SCI-823-0.00

S.R. 823 OVER S.R. 335 AND

LITTLE SCIOTO RIVER

PRELIMINARY DESIGN REPORT SUBMITTAL

FWD. ABUT. RETAINING WALL DETAILS
 BRIDGE NO. SCI-823-0248 L
 SR823 OVER SR335 & LITTLE SCIOTO RIVER

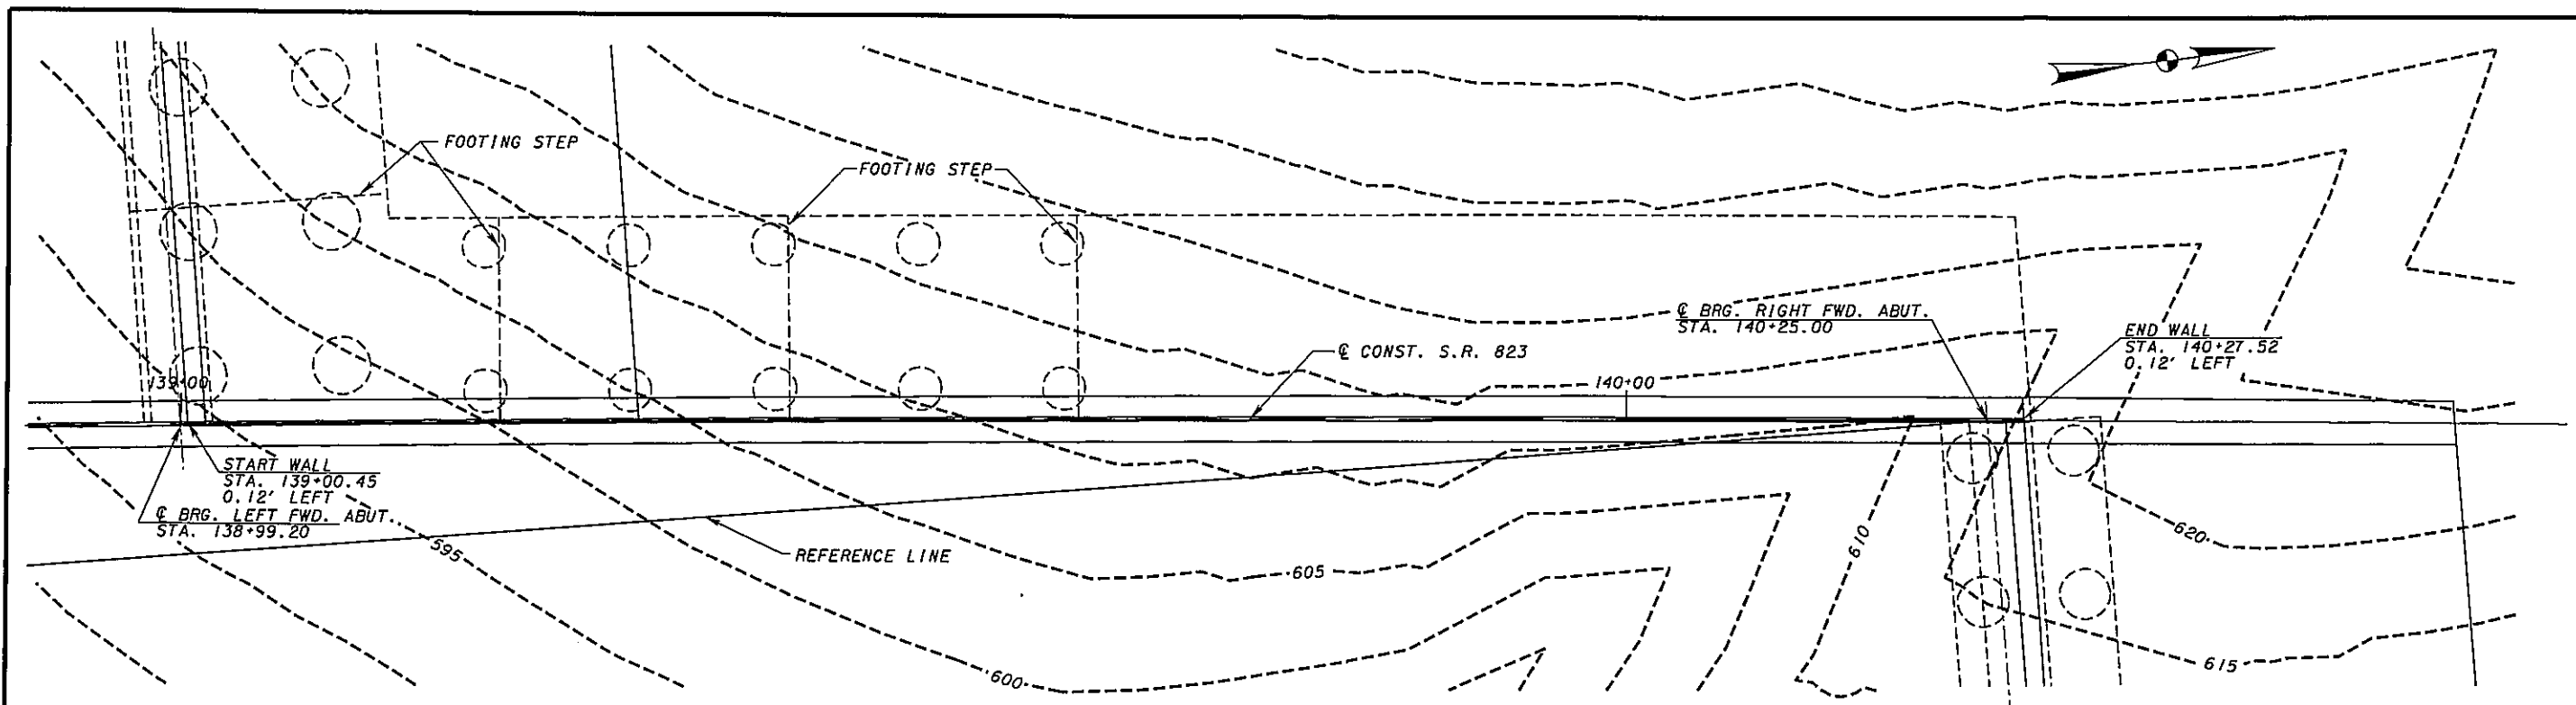
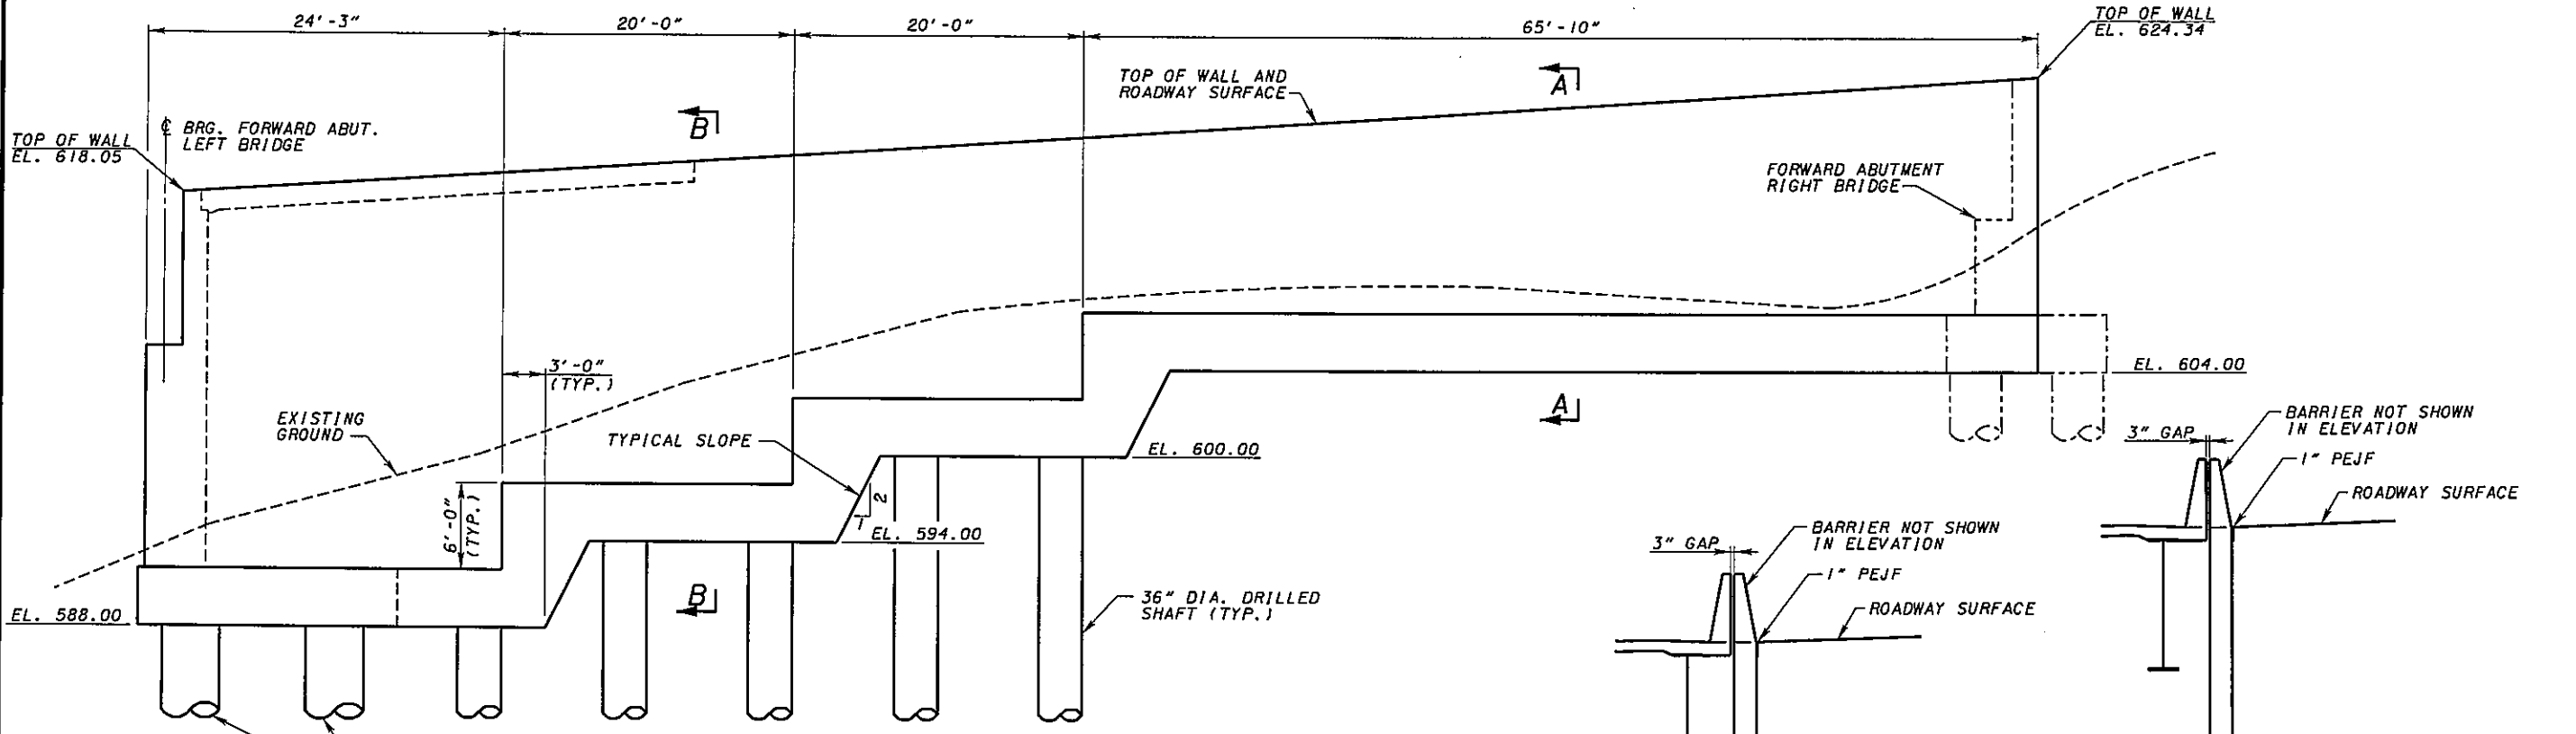
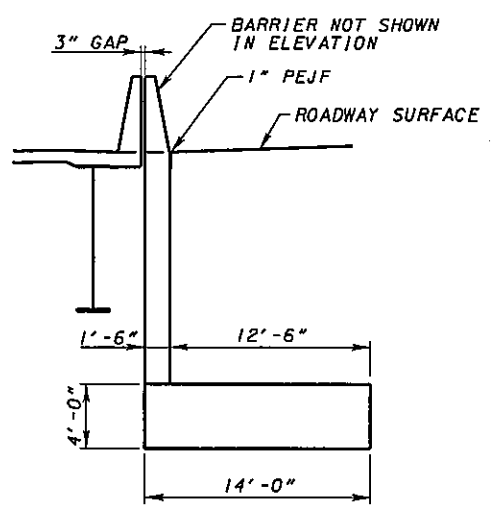
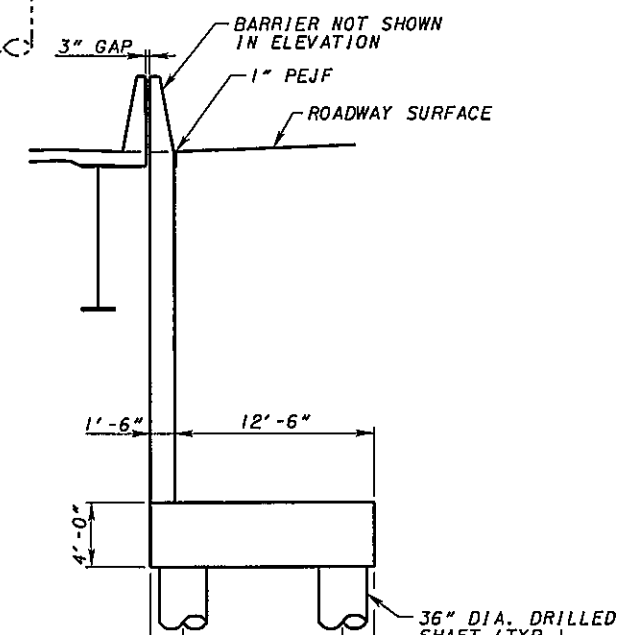
- ✓2) *Is it possible to utilize a spread footing for the left bridge forward abutment/retaining wall since the footing will be founded on bedrock?*

- ✓ 3) *We agree that the abutment/retaining wall for the left structure should be design utilizing active earth pressure. To allow this design methodology considers reducing the shoulder width across the length of thee structure by 1 inch on each side. This will result in a 3 inch separation between the median barriers.*

Pier 4R of the right bridge and the forward abutment/retaining wall of the left bridge are located in the steep hillside north of S.R. 335. Approximate top of rock profiles estimated from available boring information and contour mapping for this area reveal a sloping bedrock surface. Due to this sloping surface, the bearing depth below top of rock for a spread footing

at Pier 4R varies from 2' to over 20' (these numbers are based on DLZ's recommended bottom of footing elevation of 557.6'). Weathering and strength characteristics of the rock differ across the footing because of this variable depth and excavations of 20' or more into rock will be needed to construct the spread footing. Such excavations could undermine the foundations of the nearby proposed forward abutment and retaining wall of the left structure, regardless of whether they are spread footings or drilled shafts. To eliminate deep footing excavations and thus prevent/minimize degradation and destabilization of rock near the left structure forward abutment, DLZ recommends that Pier 4R be supported on a system of drilled shafts founded in the underlying bedrock. Due to the sloping and irregular bedrock surface in the hillside, DLZ recommends supporting the left forward abutment on drilled shafts founded in competent bedrock. When founded in such material, the drilled shafts will support superstructure dead and live loads through either end bearing or side friction and will also provide sufficient resistance to the high lateral loads generated by proposed retained fill. The retaining wall that ties into the left forward abutment and is positioned along the right fascia of the left (southbound) roadway should also be supported on drilled shafts founded in bedrock, however, as the wall height shortens (due to the slope of the underlying bedrock and proposed roadway profile elevations), lateral earth pressures on the wall decrease and the foundation system may be transitioned from drilled shafts to spread footing founded in bedrock. The spread footing will be wide enough to generate large vertical earth loads that will prevent, or minimize, rotation and sliding of the retaining wall system.

A 3" separation has been provided, as recommended, to allow for the use of active earth pressures.
